Access Compliance Report Public Rights-of-Way (Curb Ramps)

Intersection ID: 50240 Main Street: LONGSTONE_LN Cross Street: CEDAR_WALK_LN Location: SW

ADA ID: A9EF3FE8F34C Ramp Type: Combination1Diag Initial Pass/Fail: Fail Overall Compliance: No Severity Score: 0

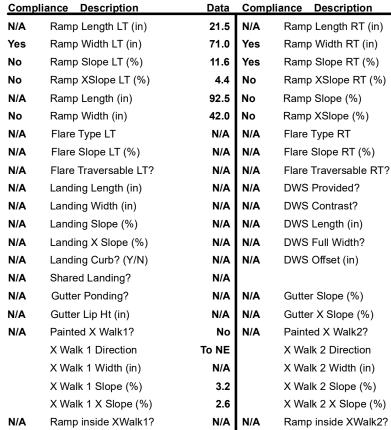
Not Found, R304.5.1, R304.2.2, R304.5.3, R304.3.2

Remove & Replace Curb Ramp With Two New Directional Ramps or Equivalent.
